**DUKE POWER**

SUBJECT: Duke Power Company  
Request for Relief from ASME Boiler and Pressure  
Vessel Code, Section III Requirements  
Duke Power Request for Relief 95-GO-002  
Additional Information  
(TAC Nos. M92625, M92626, M92619, M92620)

McGuire Nuclear Station  
Docket Nos. 50-369, 370

Catawba Nuclear Station  
Docket Nos. 50-413, 414

### CONFIGURATION 9 NB SYSTEM HEADER & UNIT 1 ECCS

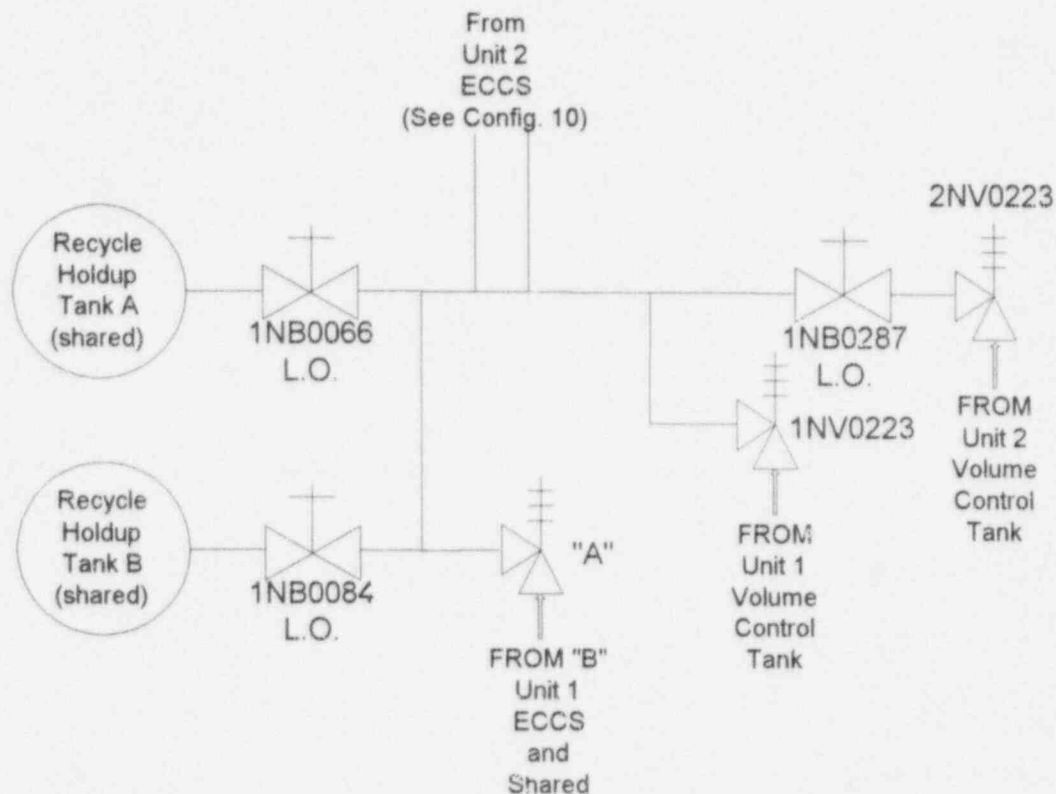
Relief previously requested for locked open block valves 1NB066 or 1NB084 is extended to include locked open block valve 1NB287 (See Configuration 9). Although shown in Figure 1 in the original 95-GO-002 Relief Request, locked open block valve 1NB287 was not specifically addressed in the June 15, 1995 letter. Relief valve 2NV223 provides pressure relief protection for the Unit 2 Volume Control Tank. It depends on locked open manual valve 1NB287 for a relief path to either Recycle Holdup Tank A or B (in addition to either of two locked open block valves 1NB066 or 1NB084 which were previously discussed in the relief request). Valve 1NB287 is an inter-unit isolation valve between Catawba Units 1 and 2 which is maintained in the locked open position.

Relief previously requested for locked open block valves 1NB066 or 1NB084 is extended to include the potentially blocked flow path for relief valve 1NB003 (See Configuration 9). Although shown in Figure 3 in the original 95-GO-002 Relief Request, relief valve 1NB003 was not specifically addressed in the June 15, 1995 letter. Relief valve 1NB003 provides pressure relief protection for the supply header to the Recycle Evaporator Feed Demineralizers. It depends on either of two locked open block valves 1NB066 or 1NB084 for a relief path to Recycle Holdup Tank A or B respectively. Both of these block valves were previously discussed in the relief request. The parallel arrangement of these valves allows maintenance isolation of either Recycle Holdup Tank without isolating the opposite tank and thus maintain a relief discharge path.

Relief previously requested for locked open block valves 1NB066 or 1NB084 is extended to include potentially blocked flow paths for relief valves in the ECCS pump suction and discharge headers. For Unit 2 ECCS suction and discharge relief valves, relief is additionally requested for block valves 1NB287, 1NB378, and 1NB395 (See Configurations 9 and 10). The Emergency Core Cooling System suction and discharge relief valves discharge into the safety related Recycle Holdup Tanks (RHTs) because of the potential for post accident coolant discharge. This includes the Safety Injection (SI) System, the Residual Heat Removal (RHR) System, the Containment Spray (CS) System, and the Centrifugal Charging (CV) System. The RHTs incorporate a flexible diaphragm which collects fission product gases.

The outlet of ECCS Pressure Relief valves 1(2)ND031, 035, 064, 1(2)NI102, 119, 151, 161, 1(2)NS002, 019 and 1(2)NV273 depend on either of two locked open block valves 1NB066 or 1NB084 for a relief path to Recycle Holdup Tank A or B respectively. Both of these block valves were previously discussed in the relief request. The parallel arrangement of these valves allows maintenance isolation of either Recycle Holdup Tank without isolating the opposite tank and thus maintain a relief discharge path. Unit 2 inputs to the Recycle Holdup Tank header include additional locked open valves, 1NB287, 1NB378, and 1NB395 which are available to provide a maintenance isolation boundary between the units.

Procedure OP/0/A/6200/03 Enclosure 4.6 lists the normal position for Recycle Holdup Tank inlet block valves 1NB066 and 1NB084 as "locked open". In addition, procedure PT/0/B/4700/40 Enclosure 13.1 requires these valves to be verified locked open annually.

Procedure OP/0/A/6200/03 Enclosure 4.6 lists the normal position for Recycle Holdup Tank inlet block valves 1NB066 and 1NB084 and Unit 2 isolation valves 1NB287, 1NB378, and 1NB395 as "locked open". In addition, procedure PT/0/B/4700/40 Enclosure 13.1 requires these valves to be verified locked open annually.

The parallel arrangement of these valves allows maintenance isolation of either Recycle Holdup Tank without isolating the opposite tank and thus maintain a relief discharge path. The alternate path would be available any time one valve might be closed for maintenance on the respective RHT. Therefore it is extremely unlikely that the relief header to at least one RHT would ever be unavailable when needed.

Relief valves 1(2) ND031, 035, 064, 1(2)NI119, 151, and 161 provide protection for the ND, and NI discharge headers which might be subjected to pressure higher than design pressure due to primary isolation valve (PIV) leakage. Relief valves 1(2)NI102, 1(2)NS002, 019 and 1(2)NV273 provide protection for NI, NS, and NV suction headers which might be subjected to pressure higher than design pressure due to either PIV leakage, leakby from interfacing systems, or pump discharge check valve leakage.

CONFIGURATION 11  
NV PUMP SUCTION

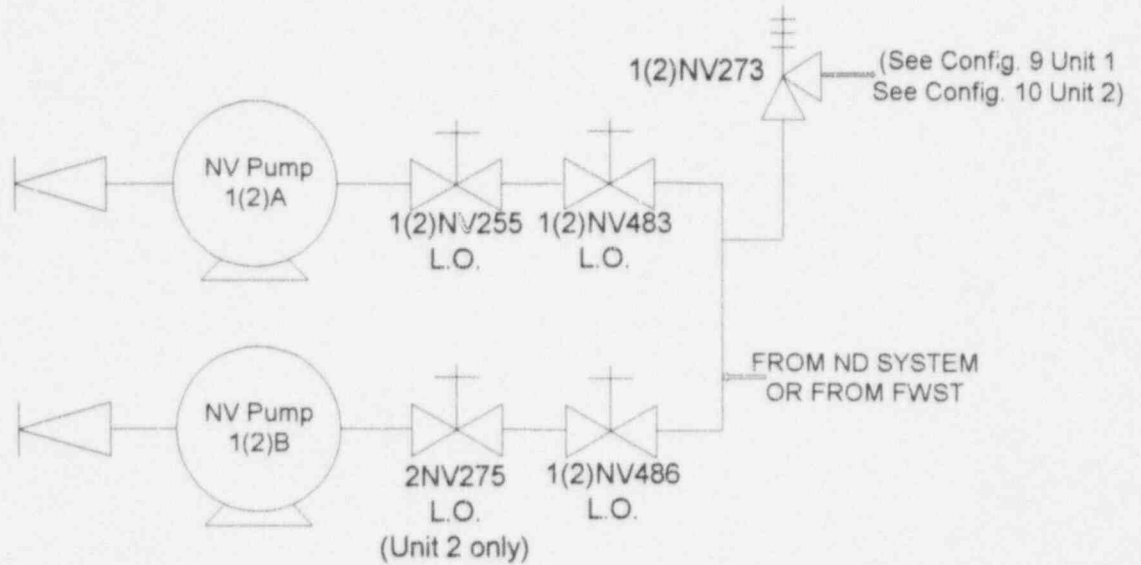
Relief is requested for locked open block valves 1(2)NV255, 2NV275(Unit 2 only), 1(2)NV483 and 1(2)NV486 (See Configuration 11).

The inlet of NV System Pump suction pressure relief valve 1(2)NV273 depends on locked open manual block valves 1(2)NV255 and 1(2)NV483 for an open relief path to the RHT for providing relief protection for NV Pump 1(2)A. Similarly relief valve 1(2)NV273 depends on locked open manual block valves 2NV275 and 1(2)NV486 for an open relief path to the RHT for providing relief protection for NV Pump 1(2)B. These manual valves are maintained locked open except for maintenance at which time the affected train is declared inoperable. The maintenance valve tagout includes closure of the pump discharge isolation valve to isolate the discharge line pressure sources and opening of a system vent to provide overpressure protection when the relief valve path is blocked.

Procedures OP/1(2)/A/6200/01 Enclosure 4.17 list the normal position for NV Pump suction block valves 1(2)NV255, 2NV275(Unit 2 only), 1(2)NV483 and 1(2)NV486 as "locked open". In addition, procedure PT/0/B/4700/40 Enclosure 13.1 requires the position of these NV Pump suction block valves to be verified annually. Additionally, Operations Maintenance Procedure 1-5 requires independent verification of the position of these valves any time they are repositioned.

The only time these pumps are isolated from their respective suction relief valve is during maintenance on the affected pump. Since the pump discharge is isolated and a vent on the affected pump is opened as part of the valve tagout for such maintenance, the operator aligning valves for the maintenance would observe any excessive or continuing vent flow and would take appropriate action to avert any situation which might lead to an overpressure event.

CONFIGURATION 12  
NI PUMP SUCTION

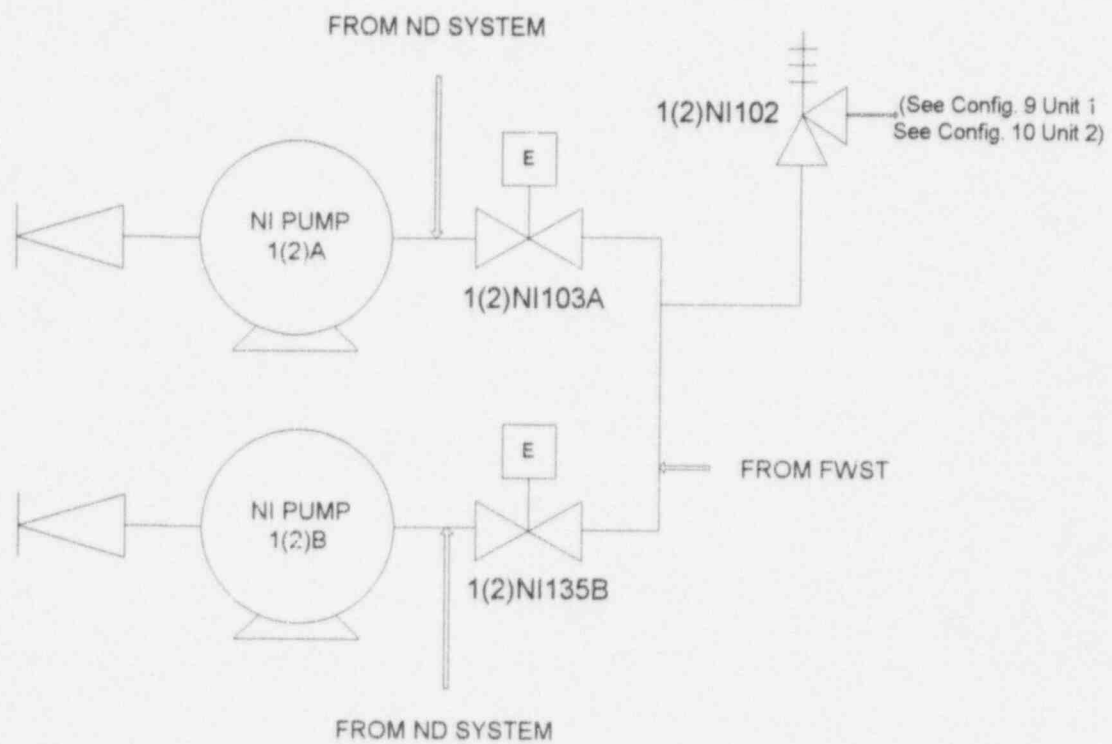
Relief is requested for normally open system isolation valves 1(2)NI103A, and 1(2)NI135B (See Configuration 12).

The inlet of NI System Pump suction pressure relief valve 1(2)NI102 depends on normally open motor operated valves 1(2)NI103A for an open relief path to the RHT for 1(2)A NI Pump. Similarly relief valve 1(2)NI102 depends on motor operated valve 1(2)NI135B for an open relief path to the RHT for providing relief protection for 1(2)B NI Pump. The normally open recirculation valves for each pump also provide relief protection for discharge check valve leakage. These motor operated valves are normally maintained open except for maintenance at which time the affected train is declared inoperable. The maintenance valve tagout includes closure of the pump discharge isolation valve to isolate the discharge line pressure sources and opening of a system vent to provide overpressure protection when the relief valve path is blocked.

Procedures OP/1(2)/A/6200/06 Enclosure 4.3 list the normal position for NI Pump suction isolation valves 1(2)NI103A, and 1(2)NI135B as "open". Additionally, Operations Maintenance Procedure 1-5 requires independent verification of the position of these valves any time they are repositioned. In addition, each of these valves is included in the NRC Reg. Guide 1.47 alarm panel which gives a visual and audible alarm whenever these valves are closed. Since these valves do not receive an open (safety injection) signal, the associated pumps are considered to be out of service any time the associated suction valve is closed. These valves must be capable of closing to provide train separation to maintain an operable train of ECCS for certain failures of the redundant train.

The system isolation valves on NI pump suction are maintained open during normal operation so that both trains of each system will be available as required to perform their ECCS function. For short durations at a quarterly frequency, valves 1(2)NI135B are stroke tested during normal operation since they only affect the associated train. It is highly unlikely that the pump suction would be overpressurized for the short duration that the suction valve would be closed for stroke testing. 1(2)NI103A is maintained open during Modes 1-3 to provide B train ECCS recirc to the NV system. Also as mentioned in the ECCS section above, the NI pump minimum flow path would provide a pressure relief path for the short time 1(2)NI135B might be closed.

For longer out of service durations these pumps are isolated from their respective suction relief valve, the pump discharge is isolated and a vent on the affected pump is established as part of the valve tagout. The operator aligning valves for the maintenance would observe any excessive or continuing vent flow and would take appropriate action to avert any situation which might lead to an overpressure event.

CONFIGURATION 13  
 AUXILIARY BUILDING KC DRAIN HEADER

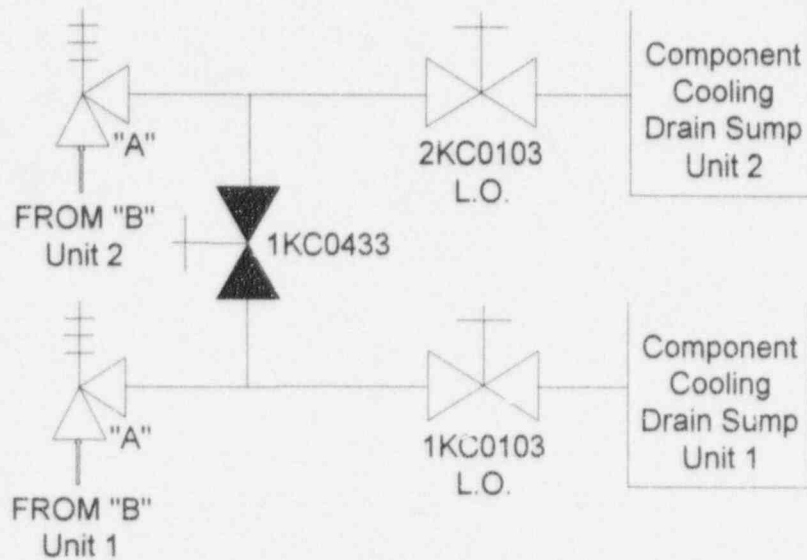
Relief is requested for locked open block valves 1(2)KC103 (See Configuration 13).

The Component Cooling System thermal relief valves located outside the Reactor Building depend on locked open manual valve 1(2)KC103 for an open relief path to the unit specific KC Drain Sump. This includes the following relief valves: 1(2)KC061, 086, 138, 147, 154, 161, and 1KC 70, 58, 461, and 472. The components protected by these thermal relief valves includes: 1(2)A(B) Residual Heat Removal and Fuel Pool Heat Exchangers, 1(2) Letdown and Seal Water Heat Exchangers, 1A(B) Waste Gas Compressor and Waste Gas Hydrogen Recombiner Heat Exchangers.

Procedure OP/1(2)/A/6400/05 Enclosure 4.6 lists the normal position for Component Cooling Drain Sump inlet block valves 1(2)KC103 as "locked open". In addition, procedure PT/0/B/4700/40 Enclosure 13.1 requires the position of these valves to be verified annually. Procedures OP/1(2)/A/6400/05 Enclosures 4.12 additionally specifies the Locked open position of 1(2)KC103 and opening of 1KC433 when this procedure is used to pump the contents of the Unit 1(2) Component Cooling Drain Sump to Unit 2(1).

Although a considerable list of equipment is included in the KC system relief valves that potentially can be isolated, the relief discharge volume from thermal expansion is considered to be an insignificant volume compared to the available gas volume expected to reside in these drain headers since they are not vented to remove air. The Auxiliary Building drain header is effectively vented via the KC Surge Tank overflow loop seals, so this acts as an additional flow path to atmosphere. Heat exchangers needed to perform post accident functions (i.e. Residual Heat Removal Heat Exchangers) would not be expected to be isolated and thus would not require thermal relief.
